17th March 2021

13-15 John's Mews, London, WC1N 2PA
Application ref. 2021/0020/P – Letter of Objection

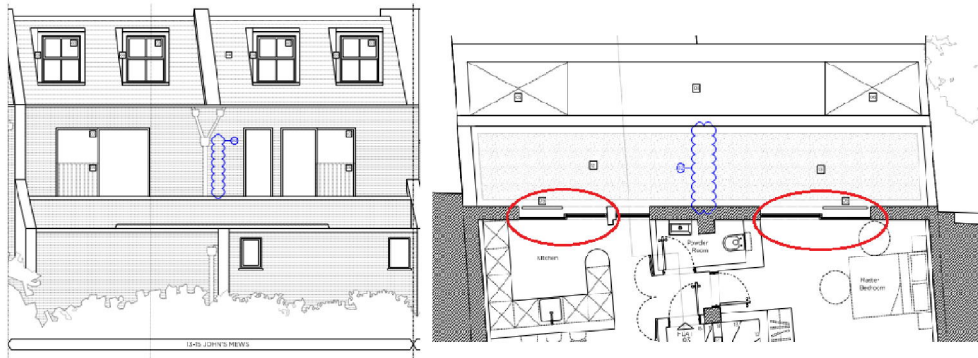
The details relating to the rear façade first floor windows and doors are unclear. Indeed, whilst the plans identify the first floor openings as 'Timber-framed French Doors', these appear to be akin to patio / sliding doors (please see the diagram below).

There is, therefore, uncertainty regarding their opening arrangement, appearance, type and finish. Furthermore, there is no information detailing the glazed panel serving the kitchen/hallway.

These details are particularly important to fully understand the impact the development has upon both the residential amenity of our clients and the setting of the designated heritage assets. They should, therefore, be forthcoming prior to the determination of the application and we request that we be given an opportunity to comment on any additional information submitted..

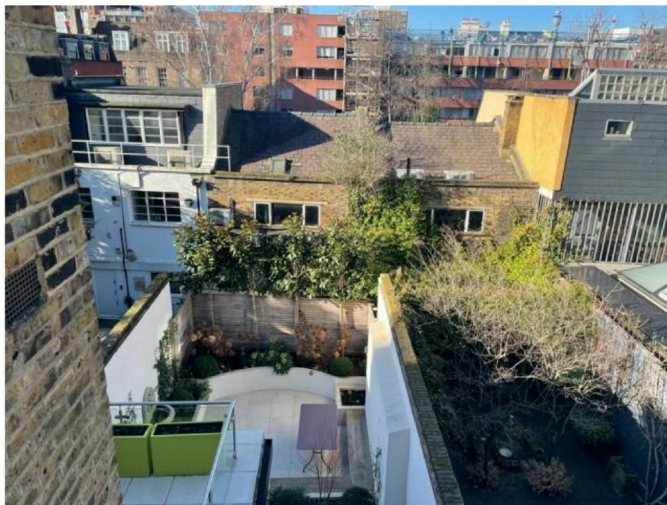
In this instance, the proposed development introduces new rear elevation windows at second floor level and significantly enlarges the existing window / door openings at the first floor level. Indeed, the first floor level of the rear façade comprises an expanse of glazing consisting of full height windows / doors.

All of the aforementioned windows serve habitable rooms and directly overlook 24 John Street and its associated private external amenity space. The proposed development will, therefore, substantially erode our client's privacy and will result in a sense of intrusion, contrary to Policy A1 and CPG - Amenity.

The overlooking relationship to our clients' private amenity space is clearly illustrated in the image below:

Whilst our clients wholly object to the principle of the new and enlarged openings within the rear façade, we acknowledge that a permission for a similar development remains extant. Therefore, should permission be forthcoming, in line with CPG – Amenity, against which this application should be assessed, we would respectfully request that mitigation measures be included to reduce the potential for loss of privacy.

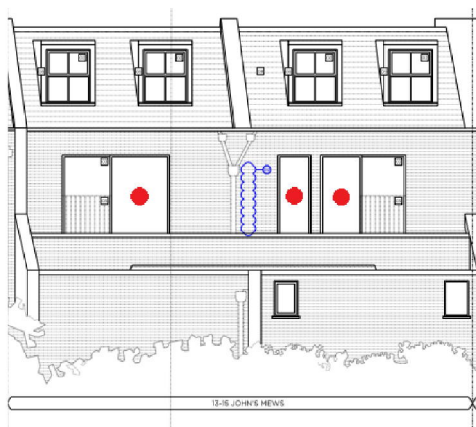
Firstly we would recommend that a condition be imposed to introduce obscured glazing as per our suggestions below (recommendations marked in red):

Similarly we would request that these openings be conditioned to remain permanently fixed shut to further eliminate the potential for overlooking and, as we set out below, to mitigate noise pollution and spillage.

The application also includes a flat sedum roof directly abutting the first floor openings. To prevent the creation of a 'viewing platform' we would request that a condition be imposed to formally restrict the roof from being accessed and used as a balcony / terrace. We would also request that the plans be amended to ensure that the railings serving the Juliette balconies are extended and positioned to run flush to the rear elevation to prevent any gaps which may facilitate access to the roof.
